NOTICE TO TENDERERS NO: 1
Pages: 16 (this letter), 30 (presentation)

21 August 2026

033Q/2026/27: BUILDING CONSTRUCTION WORK OF PHILIPPI SWITCHING STATION AND BUILDING ALTERATIONS

Figure 9: Acceptable earth grid installation methods

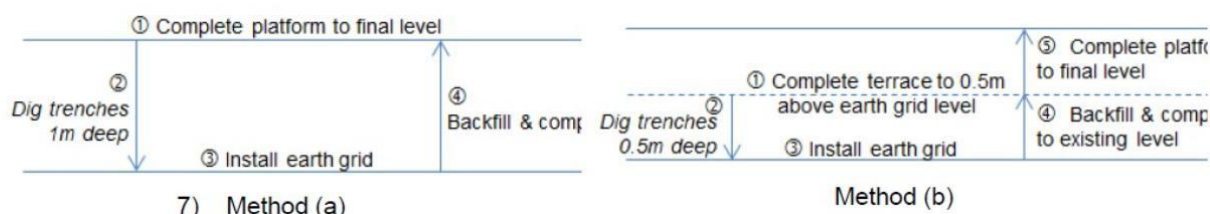
The only two acceptable earth grid installation methods are described below and illustrated in Figure 9.

- a) Complete the platform to the final specified level and then install the earth grid:
 - 1) Complete the platform to the final design level,
 - 2) Trench to the specified earth grid depth,

- 3) Install the earth grid as specified,
 - 4) Backfill and compact the trenches at optimum moisture content with a mechanical plate compactor in layers not exceeding 300mm to a density of 93% Mod AASHTO to the final platform level.

- b) Install the earth grid before the final platform level has been reached:
 - 1) Complete the platform only to 0.5m above earth grid level,
 - 2) Trench 0.5m deep,

- 3) Install the earth grid as specified,
 - 4) Backfill and compact the trenches at optimum moisture content with a mechanical plate compactor (or similar hand compactor) in maximum layers not exceeding 300mm to a density of 93% Mod AASHTO to the existing platform level,

- 5) Backfill and compact the whole platform to final level as specified.
